P 519856

ON-SITE SEWAGE DISPOSAL SYSTEM HOWARD COUNTY HEALTH DEPARTMENT BUREAU OF ENVIRONMENTAL HEALTH

ADDRESS: 11525 Johns Hopkins Road PROPERTY OWNER: Peter David

RE: 11525 Johns Hopkins Road

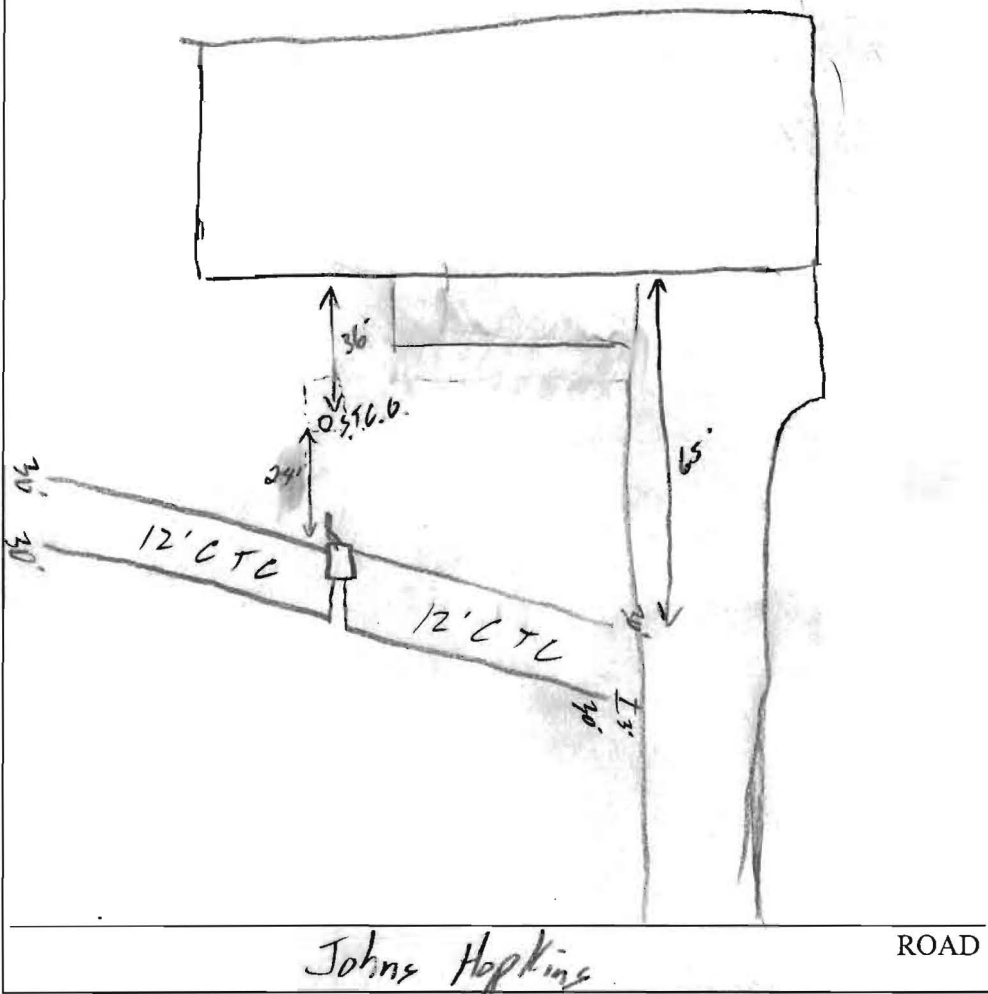
TRENCHES:	Trench to be <u>2</u> feet wide. Inlet <u>6</u> feet below original grade. Bottom maximum depth <u>10</u> feet below original grade. Effective area begins at <u>6</u> feet below original grade. <u>4</u> feet of stone below distribution pipe.
LOCATION:	<u>Use good levelers w/ D.W. all the way up, trenches all the way down</u>
PURPOSE:	Septic system is failing. Call for inspection when the ground has been opened so sanitarian can recommend repair.
